Our Case Number: ABP-316272-23

**Re: Bus Connects Templeogue/Rathfarnham to City Centre Core Bus Corridor Scheme
Templeogue/Rathfarnham to City Centre**

Project name: Bus Connects Templeogue/Rathfarnham to City Centre Core Bus Corridor Scheme

ABP case reference number: HA29N.316272

Figure 2 The excellent SDCC N81 scheme in Tallaght with reduced crossing distances and green buffer to the cycle tracks

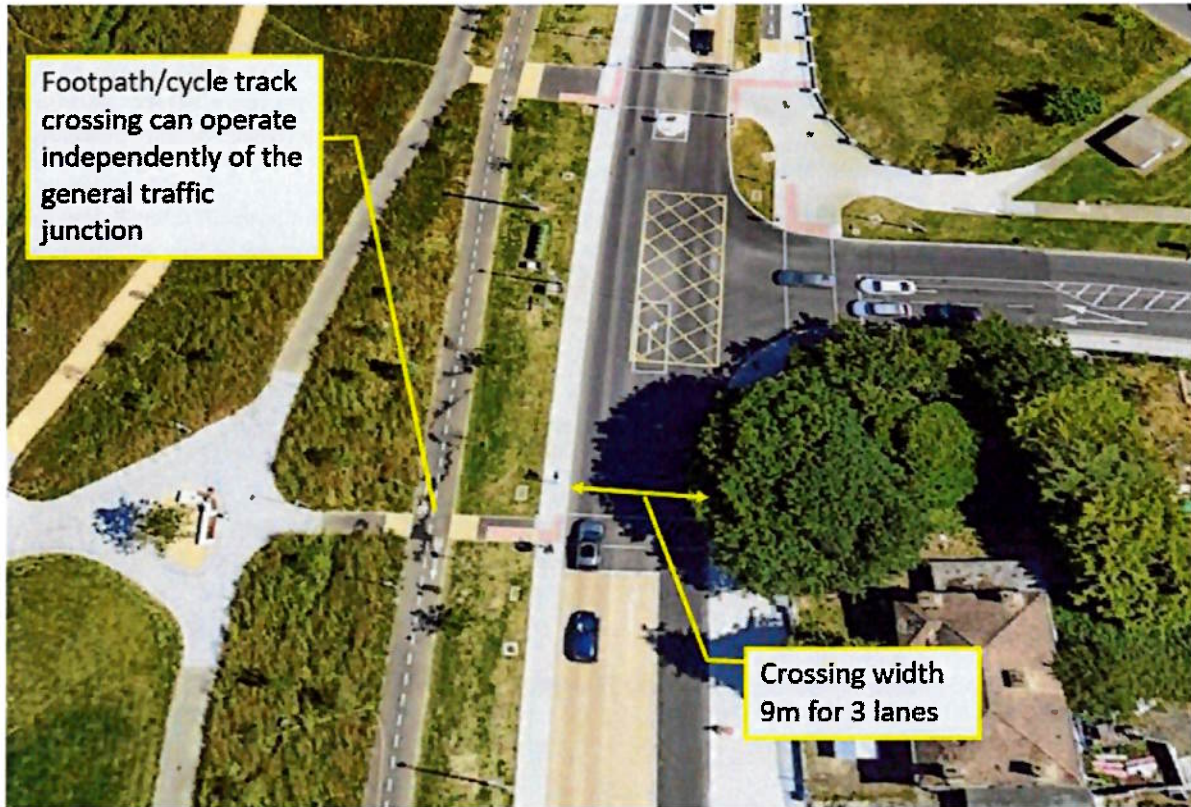
General traffic lanes are shown on the typical sections up to 3.6m wide. These lanes widths are more in line with the motorway and dual carriageways lane widths specified in TII publication *Cross Sections and Headroom* (DN-GEO-03036) which not the applicable standard. Lane widths should be in accordance with DMURS (refer above). Reduced lane widths would also reduce the total paved area (thereby reducing run-off) and reduce future pavement maintenance costs. Excess space should be assigned to the footpaths, cycle tracks or the provision of green verges. Where at all feasible, green buffer space should be provided between the cycle track and the road to increase comfort.

Separating cycle tracks and footpath crossings from general traffic lanes could help to reduce road crossing widths and delays, as the ped/cycle crossings can be run on a different cycle to the main junction. This principle is used in the Busconnects Junction Type 4 and the principle should be utilised more widely in the scheme at crossings and junctions where feasible. Reducing the visible cross-section would also help to reduce driver speed.

The benefits of this approach are that the distances pedestrians must cross in one go are reduced and additional junction time can be saved, This additional time can be used for bus or motor traffic or for additional pedestrian/cycle crossing opportunities – which means less waiting and delay. I encourage ABP to visit the excellent SDCC N81 scheme in Tallaght (refer below) to experience the improvements this approach can bring and then to compare it to a Busconnects type crossing at Ballyboden St. Enda's clubhouse on the Firhouse Rd. (visit on Saturday afternoon when children must scramble to get across).

Figure 4 The Dodder and M50 form barriers to active travel & the Busconnects Section 1 Key Junctions are critical to providing access across them

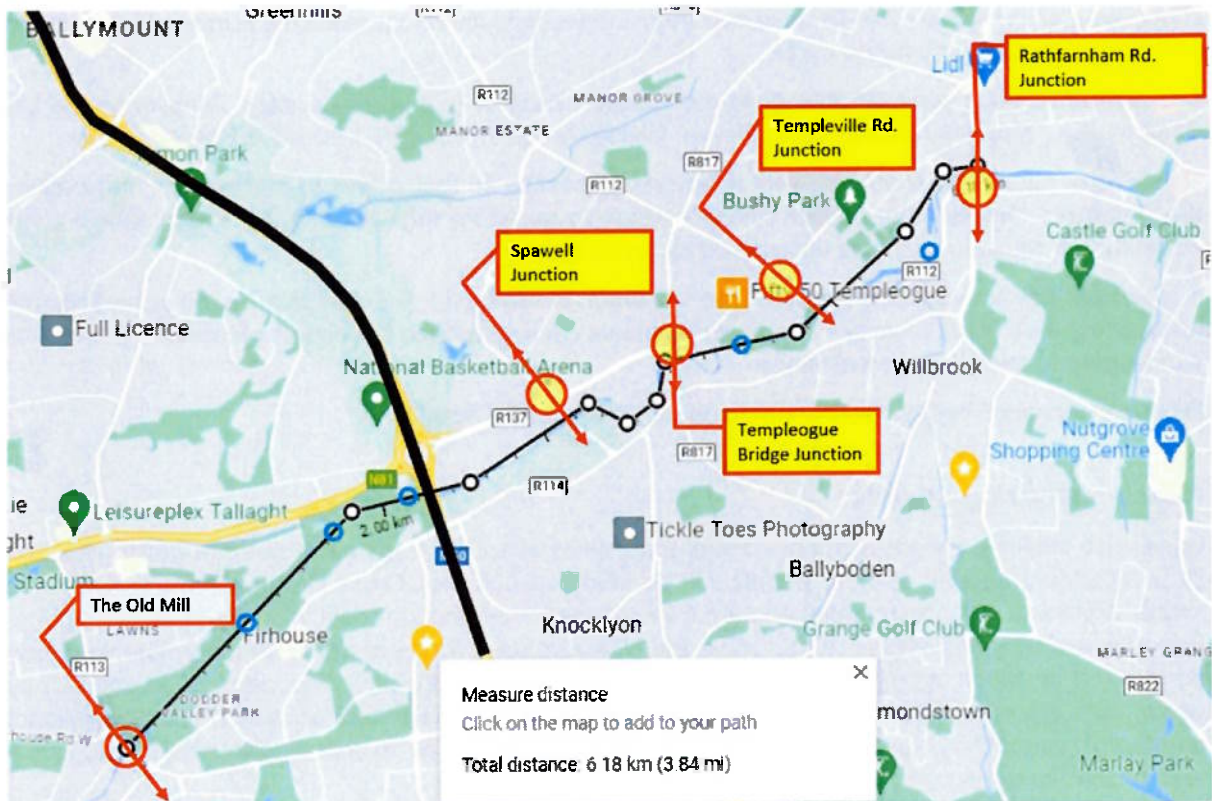
The Dodder and M50 Motorway form significant barriers to active travel in this part of the city. Figure 4 shows the Dodder and M50 with four Section 1 Key Junctions highlighted in yellow. Recently SDCC/NTA have completed some off-road greenway bridges, these are marked in blue circles. While they are a significant help to active travel, it is imperative on road facilities are also provided.

Between the Old Mill (Tallaght) and Terenure Village (~6.2km) if you want to cycle across the Dodder River on-road you must use one of these 4 key junctions. It is critically important for active travel that these junctions prioritise walking and cycling, not just along the Busconnects routes, but across them. Access across these junctions will also be key to accessing the Kimmage Busconnects route from areas such as Rathfarnham, Ballyboden, Knocklyon and Firhouse, and to access the Dodder Greenway.

Figure 6 Extract from the drainage drawings showing the omitted Templeogue Village Catchment

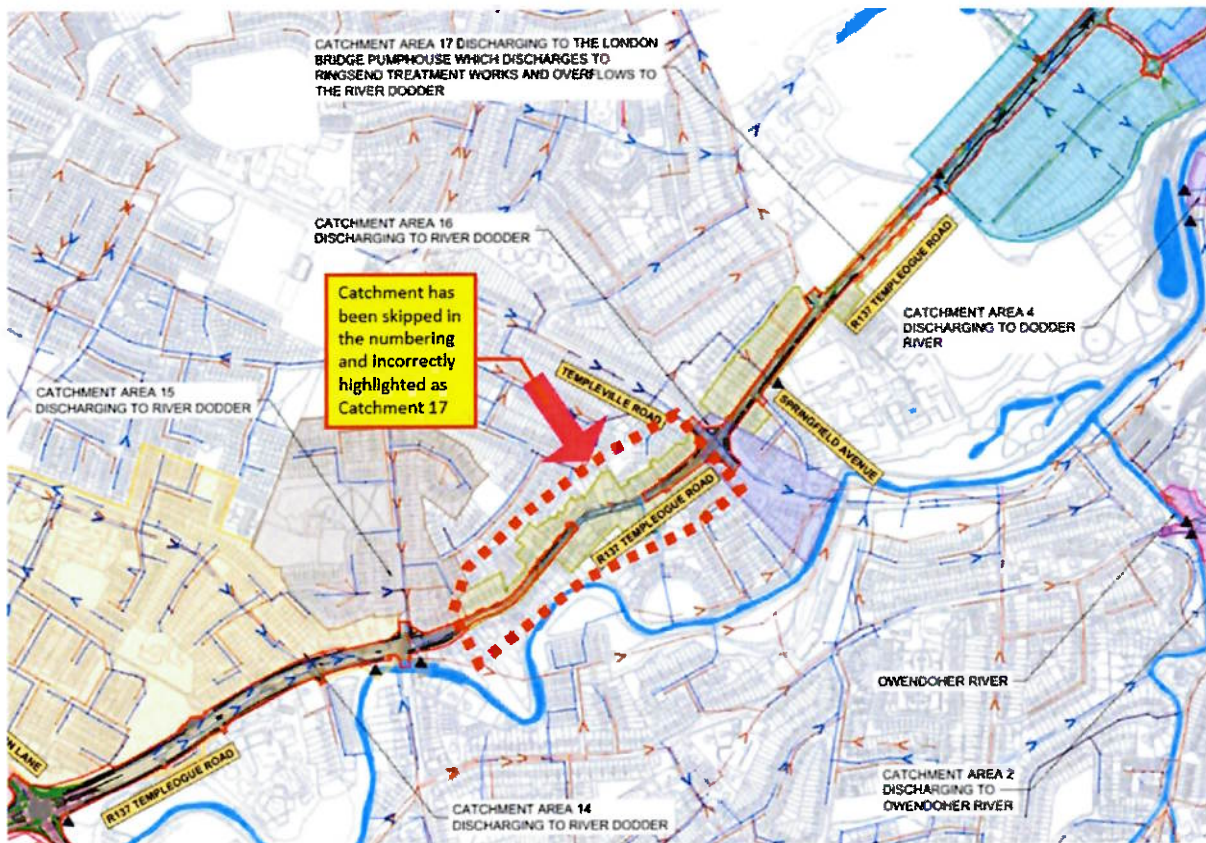
There are a series of inaccuracies and errors included the planning documents relating to the drainage and catchments, please refer to the following table.

Table 9.2: Summary of Existing Catchments	The Templeogue Village Catchment (chainage J1550 to J2115) has been omitted from the table. It has incorrectly been listed under Catchment 17 and the discharge	The Templeogue Village Catchment should be numbered, and the discharge accurately described. It does not discharge to a treatment plant, but rather through the Templeogue Village

Figure 9 Busconnects proposals will needlessly downgrade some good existing cycling infrastructure

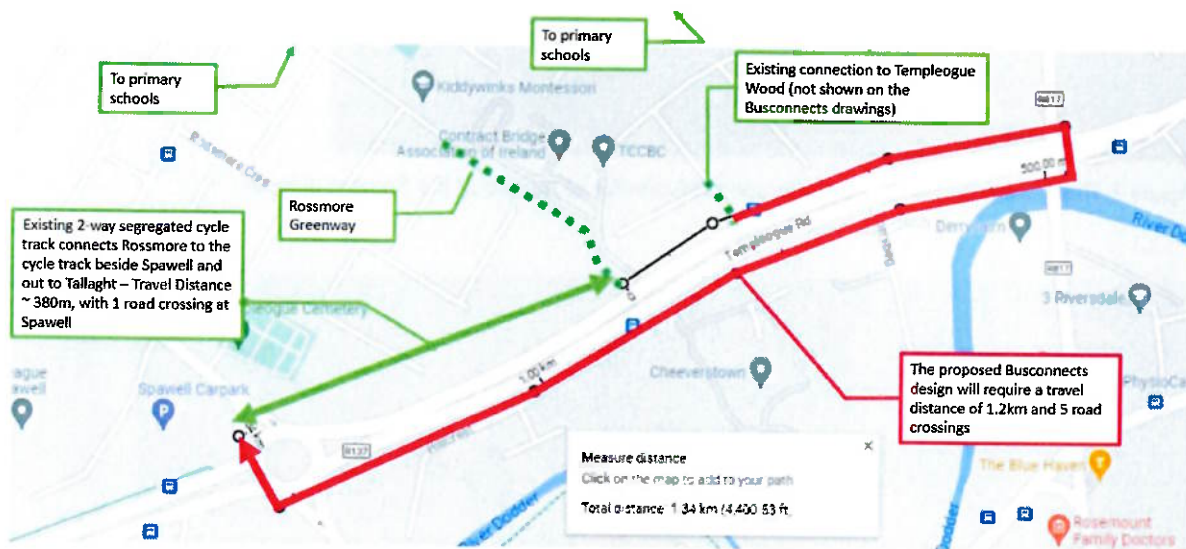
The existing two-way cycle track between the Rossmore greenway and Spawell should be retained. The route currently serves residential areas, the primary schools and other local amenities well. Busconnects proposes to downgrade it to a one-way track. By removing the existing two-way cycling track people will have to travel longer and cross large roads numerous times in order to connect to the Wellington Lane cycle track or the Tallaght cycle track at Spawell, refer figure below.

The key pedestrian and cycling entrance to Templeogue Wood should also be retained. Busconnects appears to ignore it. The two-way cycle track should be extended from the toucan crossing outside Cheeverstown House to the pedestrian/cycling access into Templeogue Wood. Without a two-way track, people cycling from Templeogue Wood will have to travel ~700m longer and cross 4 extra roads to connect to Wellington Lane or the cycle track at Spawell (see below).

Figure 10 Proposed Busconnects Routes at Templeogue Bridge

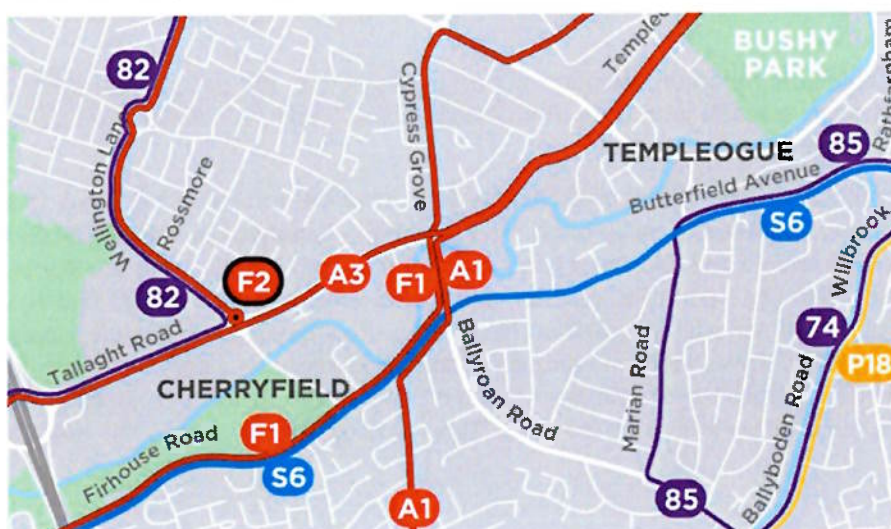
The proposed outbound bus stop is relocated from the east to the west of the junction. The proposed location is too far away and disadvantages bus users, most of whom will now have further to walk to access Cypress Grove Road or Old Bridge Rd (where they mostly go). Furthermore, the design of the junction at Templeogue Bridge will not provide people with a pedestrian crossing over the R137, so bus users will have to cross an additional road (in some cases cross 3 roads & 4 beg buttons - Old Bridge Road, Templeogue Road and Cypress Grove Road) to access Cypress Grove Road, which should be one crossing. The design proposals should promote and encourage sustainable travel.

The bus stop placement also reduces options for bus users, as the A1 will turn down Old Bridge Road and stop 1130 will no longer service half of the proposed outbound bus routes. The bus stop placement will also hinder and restrict transfer access between the A1 and A3 spines and the F1 spine. There is no pedestrian crossing provided on the western arm of the major junctions, which would connect transferring passengers. Most passengers alighting at Templeogue Bridge walk up Cypress Grove Road (including to use the pedestrian permeable routes at Cypress Grove North and South). The proposed bus stop placement lengthens their walk from the stop and requires additional road crossings.

Figure 16 Busconnects CBC10 Public Consultation 2 with the Village removed, note reference to TVI Part 8

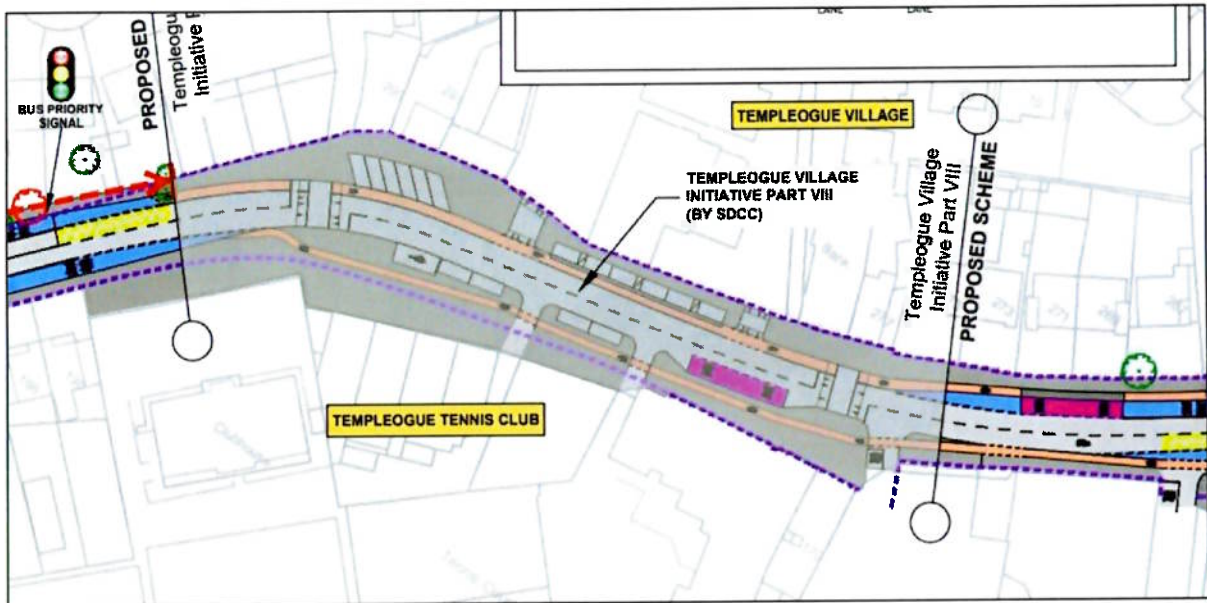
In January 2020 the NTA publicly announced that Templeogue Village would be removed from their plans to enable SDCC to progress the TVI Part 8 plans. This removed the Village from the second Busconnects public consultation conducted April 2020, as evidenced by the drawing below.

As Busconnects CBC10 is a continuous route, the SDCC TVI will ultimately form part of the Busconnects design which has been submitted to An Bord Pleanala.

Figure 19 SDCC TVI Part 8 Plan 2018 indicating deliberately restricted red line boundaries.

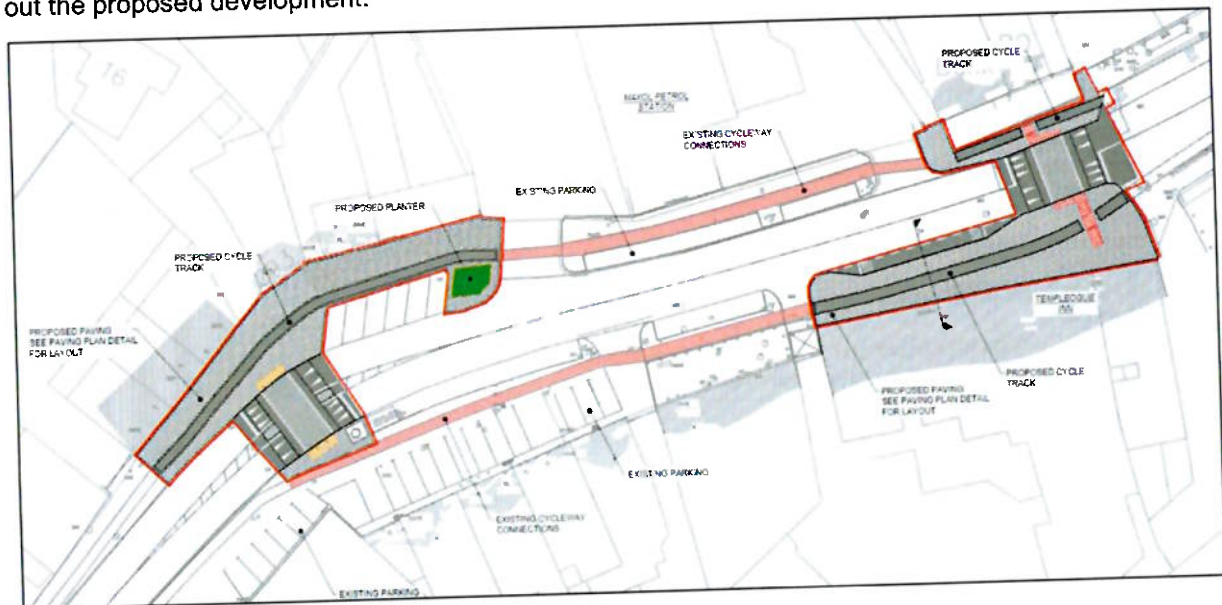
The 2018 Part 8 planning drawing included red line boundaries which appear quite deliberately drawn to limit their extent and not include on-street parking. The proposed design includes extensive material differences that result in works well beyond the areas coloured to identify the works. Refer to the drawings appended.

- The existing northern cycle track is realigned completely, moved outside the parking protection, and desegregated.
The drawing shows the alignment of the existing tracks unaltered.
- The existing roadway kerb lines are extensively realigned on both sides of the street.
The drawing shows the existing roadway unaltered.
- Roadway widened beyond the eastern gateway to lengthen the bus lane.
The drawing shows no works in this area.
- Extensive alterations to existing parking arrangements are proposed, including materially changing:
 - the disabled parking provisions
 - the location, orientation, and operation arrangement of the 6-bay echelon parking on the north side of the Village
 - the location of and access/egress arrangement to the parallel bays in front of the service station (i.e. a driver must now drive and/or reverse along a cycle lane to use the parking)

The drawing shows no change to existing parking arrangements.
